## PIC16(L)F1934/1936/1937 Family Silicon Errata and Data Sheet Clarification

The PIC16(L)F1934/1936/1937 family devices that you have received conform functionally to the current Device Data Sheet (DS41364E), except for the anomalies described in this document.

**FIGURE 1: INSTRUCTION CYCLE DELAY CALCULATION EXAMPLE**

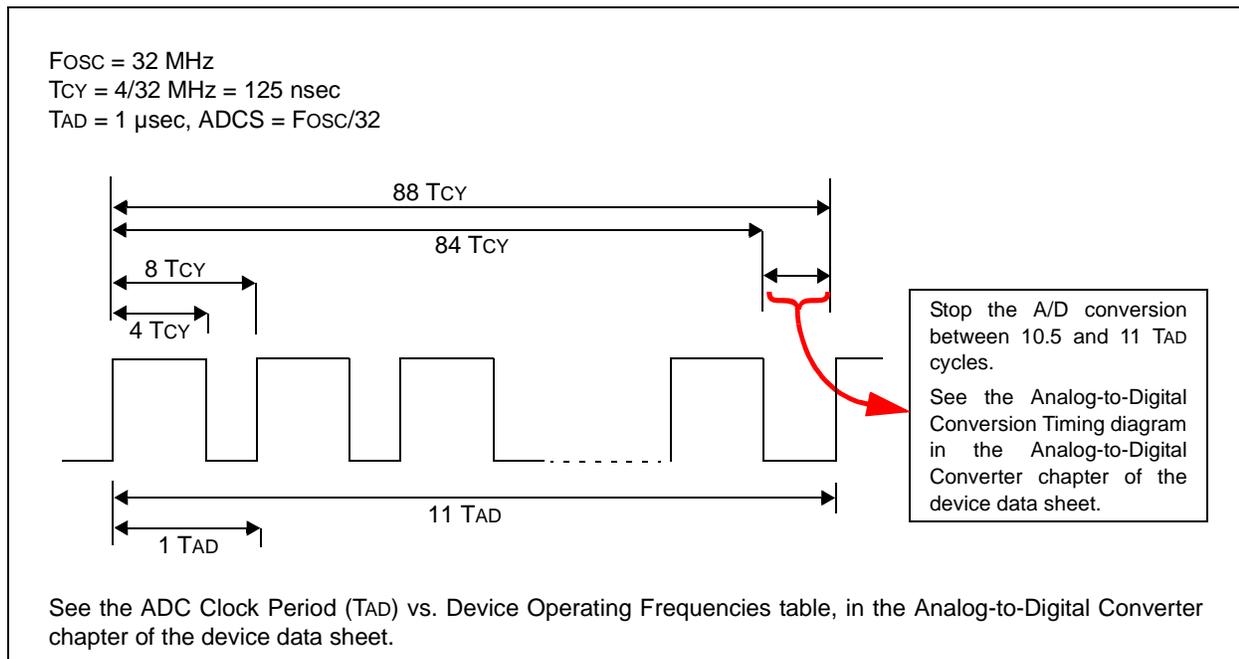
An ADC conversion may not complete under these conditions:

1. When FOSC is greater than 8 MHz and it is the clock source used for the ADC converter.
2. The ADC is operating from its dedicated internal FRC oscillator and the device is not in Sleep mode (any FOSC frequency).

When this occurs, the ADC Interrupt Flag (ADIF) does not get set, the GO/DONE bit does not get cleared, and the conversion result does not get loaded into the ADRESH and ADRESL result registers.

Method 3: This method is provided if the application cannot use Sleep mode and requires continuous operation at frequencies above 8 MHz. This method requires early termination of an ADC conversion. Provide a fixed time delay in software to stop the A-to-D conversion manually, after all 10 bits are converted, but before the conversion would complete automatically. The conversion is stopped by clearing the GO/DONE bit in software. The GO/DONE bit must be cleared during the last 1/2 TAD cycle, before the conversion would have completed automatically. Refer to [Figure 1](#) for details.

In [Figure 1](#), 88 instruction cycles (TCY) will be required to complete the full conversion. Each TAD cycle consists of 8 TCY periods. A fixed delay is

provided to stop the A/D conversion after 86 instruction cycles and terminate the conversion at the correct time as shown in the figure above.
